EXHAUST - EXHAUST SHROUD IMPROVEMENT

208

208B

CAB-78-03
Page 1 of 9

Figure 1. Exhaust Shroud Strap Installation (Sheet 1)

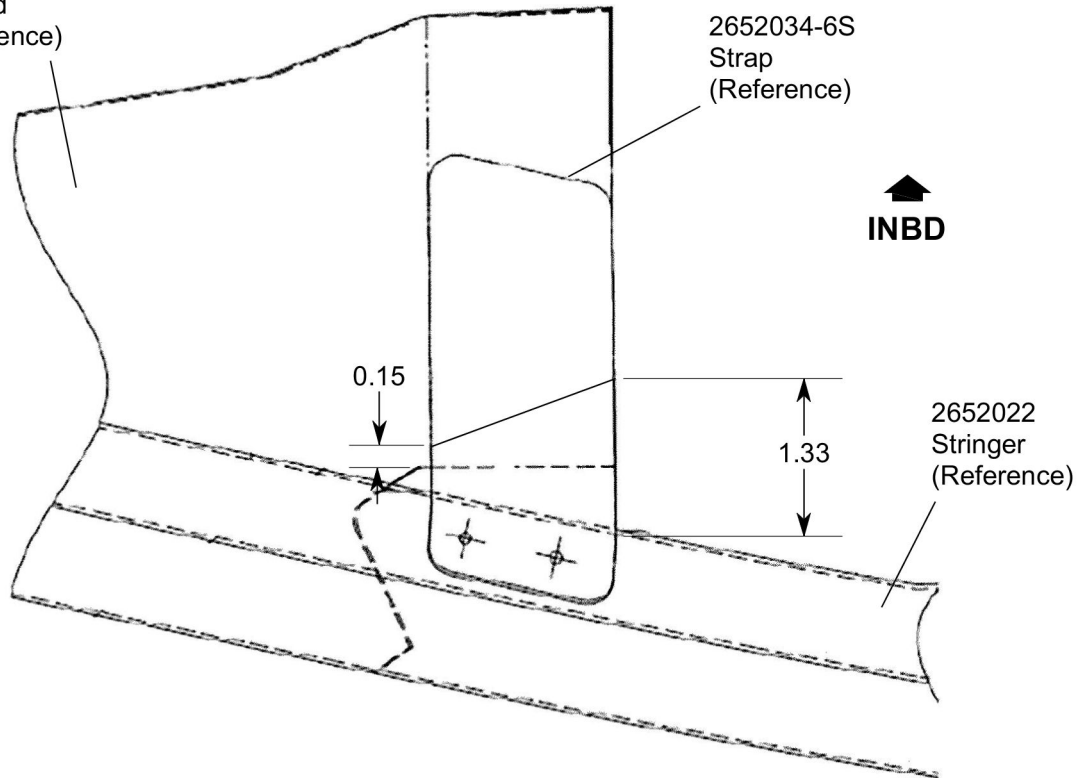
1. Prepare the airplane for maintenance.
 - A. Make sure that the airplane is electrically grounded.
 - B. Make sure that all switches are in the OFF/NORM position.
 - C. Disconnect electrical power from the airplane.
 - (1) Disconnect external electrical power.
 - (2) Disconnect the airplane battery.
 - D. Attach maintenance warning tags to the battery and external power receptacle that have **"DO NOT CONNECT ELECTRICAL POWER - MAINTENANCE IN PROGRESS"** written on them.
2. Open the right engine door.
3. (Refer to Figure 1, Sheet 1.) Make a measurement on the 2652022-7/-103 Shroud as follows:
 - A. Temporarily put the 2652034-6S Strap onto the 2652022-7/-103 Shroud.
 - B. On the forward edge of the 2652022-7/-103 Shroud, measure and mark 1.33 Inch from the inboard edge of the 2652022 Stringer with a marker.

- C. From the radius of the aft edge of the 2652022-7/-103 Shroud, measure and mark 0.15 Inch where the mark would meet with the 2652034-6S Strap with a marker.

- D. Remove the 2652034-6S Strap and connect the two measurements on the 2652022-7/-103 Shroud with a marker.
4. Make sure that any cracks and/or drill stops are below the drawn line on the 2652022-7/-103 Shroud.

Figure 1. Exhaust Shroud Strap Installation (Sheet 2)

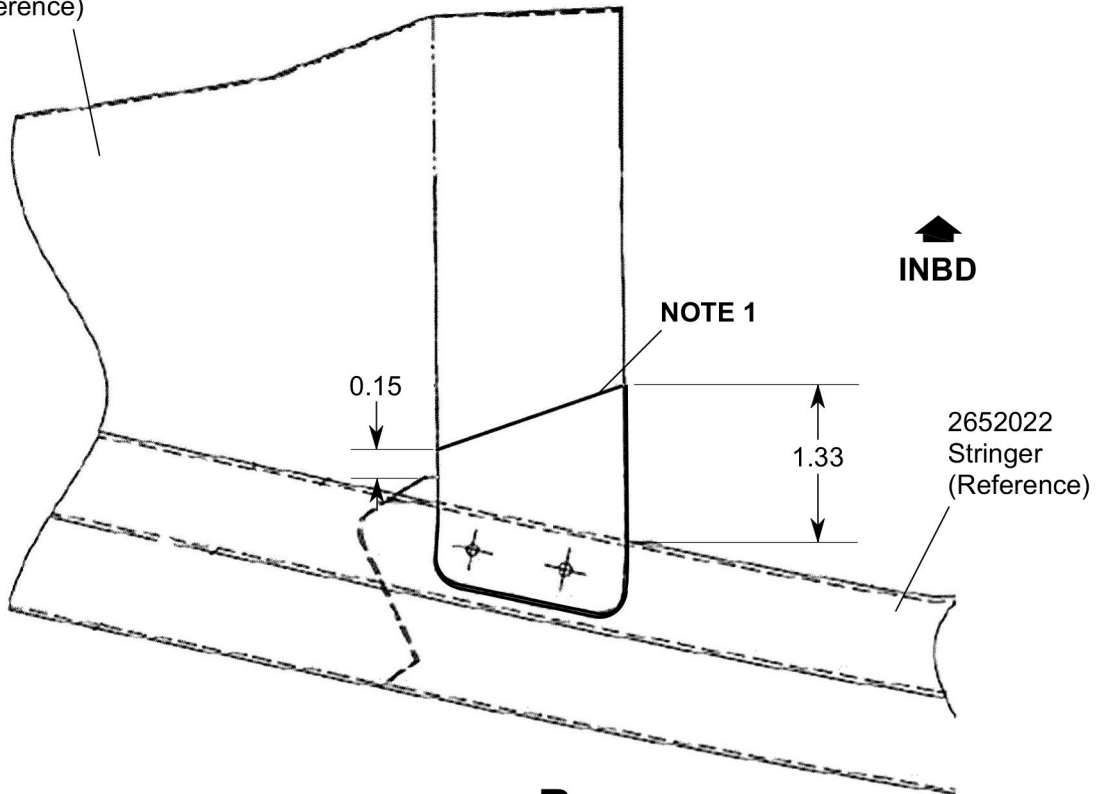
7. (Refer to Figure 1, Sheet 2.) Remove the cracked area of the 2652022-7/-103 Shroud as follows:
- A. Remove the two rivets that attach the 2652022-7/-103 Shroud to the 2652022 Stringer. (Refer to the Model 208 Series Structural Repair Manual, Chapter 51, Fasteners.)

- B. Remove and discard the cracked area of the 2652022-7/-103 Shroud.
- C. Remove all ragged edges of the 2652022-7/-103 Shroud.
- D. Round all corners of the 2652022-7/-103 Shroud.

NOTE 1: Remove the bolded area below the marked line of the 2652022-7/-103 Shroud.

Figure 1. Exhaust Shroud Strap Installation (Sheet 3)

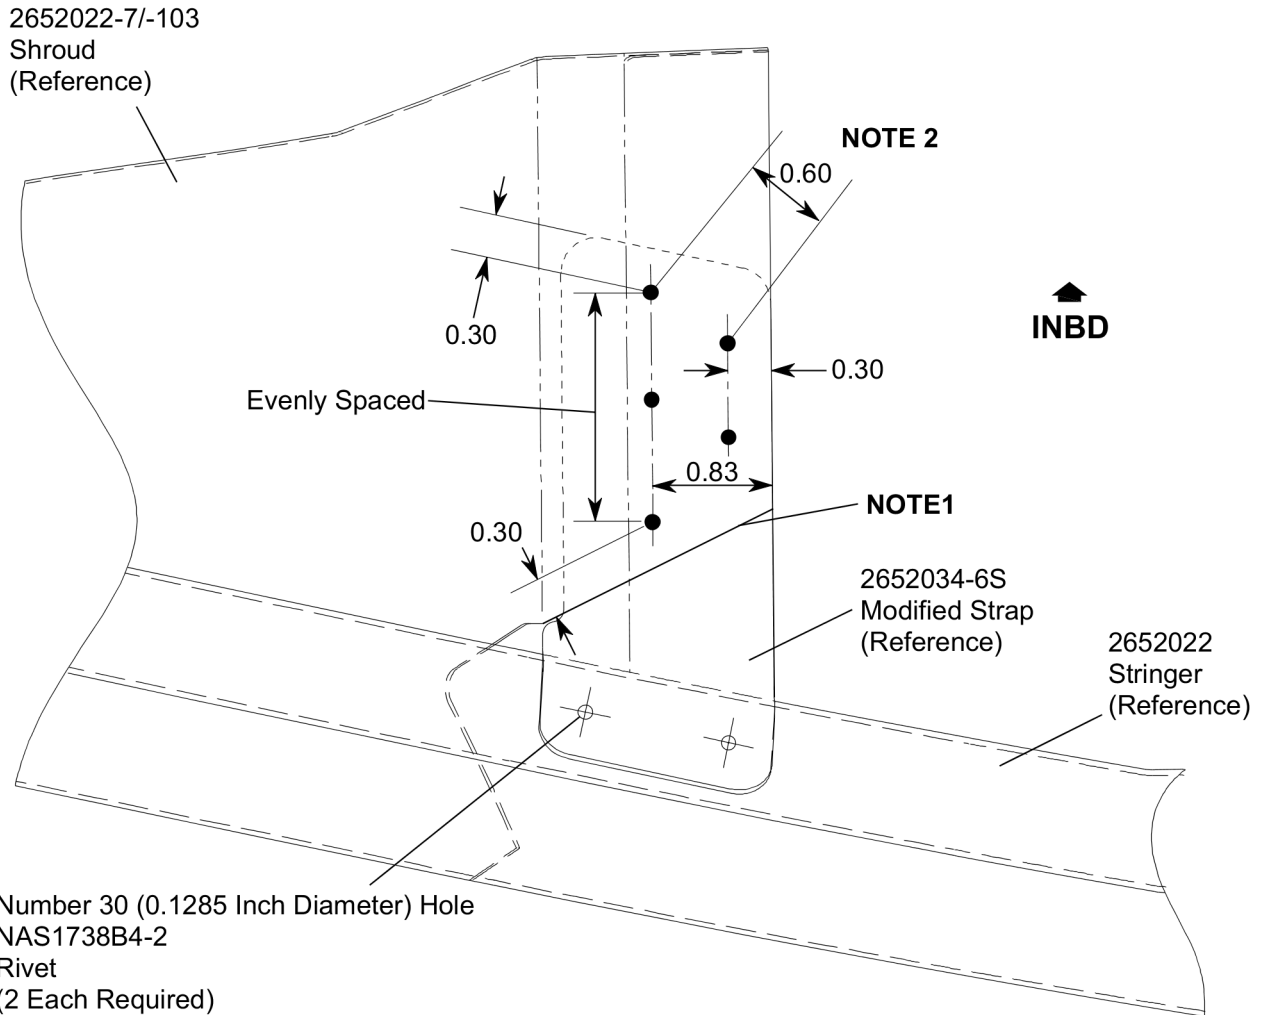
- E. Apply Color Chemical Film Treatment to all bare metal.
- F. Apply Corrosion Resistant Primer to all exposed bare metal.
8. (Refer to Figure 1, Sheet 3.) Install the 2652034-6S Strap as follows:

- D. Place the modified 2652034-6S Strap onto the inboard side of the 2652022-7/-103 Shroud.
 - E. Drill the five Number 30 (0.1285 inch diameter) holes through the 2652022-7/-103 Shroud and the modified 2652034-6S Strap.

- F. Debur all drilled holes.
 - G. Countersink the five holes to 100 Degree x 0.128 Inch Diameter , on the inboard side, of the modified 2652034-6S Strap.

- L. Place and align the holes of the modified 2652034-6S Strap onto the inboard side of the 2652022-7/-103 Shroud
 - M. Install the five MS20426AD4-4 Rivets into the modified 2652034-6S Strap and through the 2652022-7/-103 Shroud. (Refer to the Model 208 Series Structural Repair Manual, Chapter 51, Fasteners.)

NOTE 2: The 0.60 inch dimension is the minimum distance that is allowed.

Figure 2. Exhaust Strap Modification (Sheet 1)

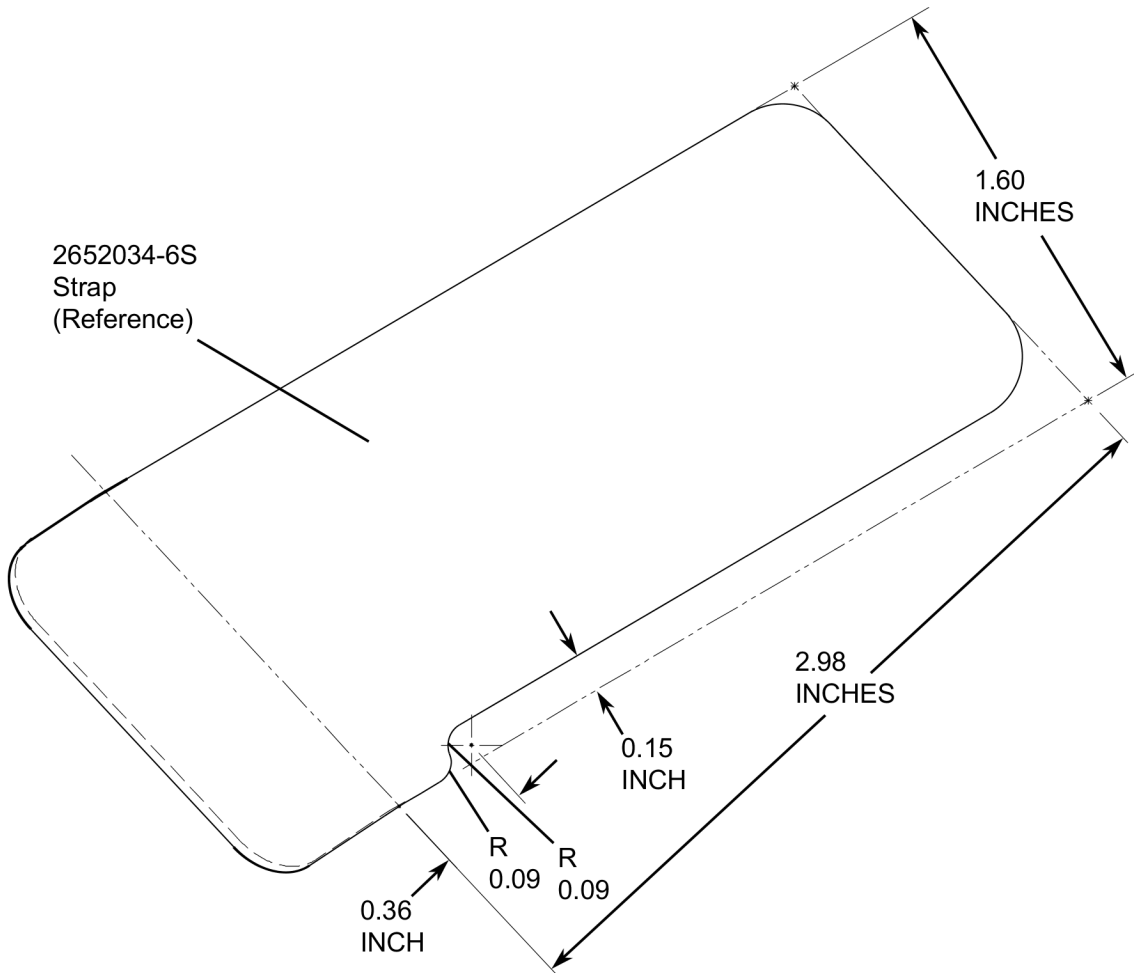
- A. (Refer to Figure 2, Sheet 1.) Modify the 2652034-6S Strap as shown in Figure 2, Sheet 1.
